Planning Application No: SCC/0045/23E. – Acorn Bioenergy

Location: Land to the north of Spring Grove Farm, Withersfield, CB9 7SW

Acorn's Regulation 25 Environmental Statement Addendum- Highways Sections 3

Image 3

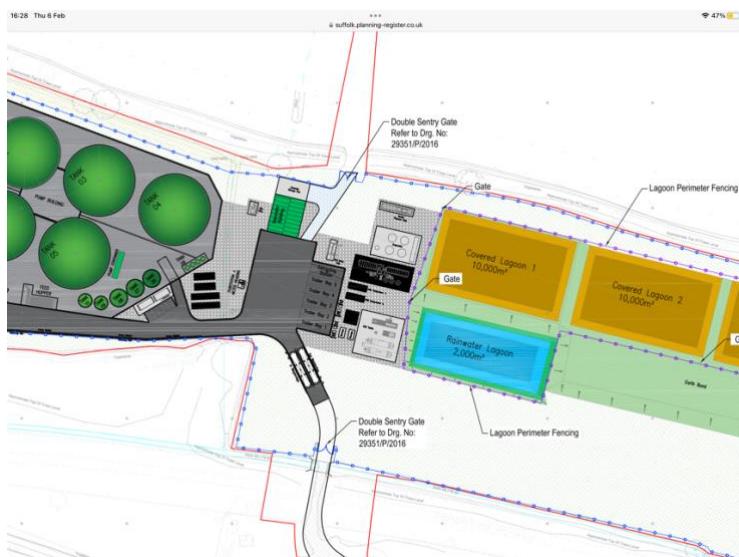
- *Transport Addendum (Motion) Appendix C withing Appendix G Page 16 drawing 2401110-TK01 (See image 3 below)* This illustrates the entry and exit manoeuvre within the site for vehicles parking in the trailer bays coming from the A1307 but does not show a north gate or show the north gate structure. **Referred to in 5c) below.**
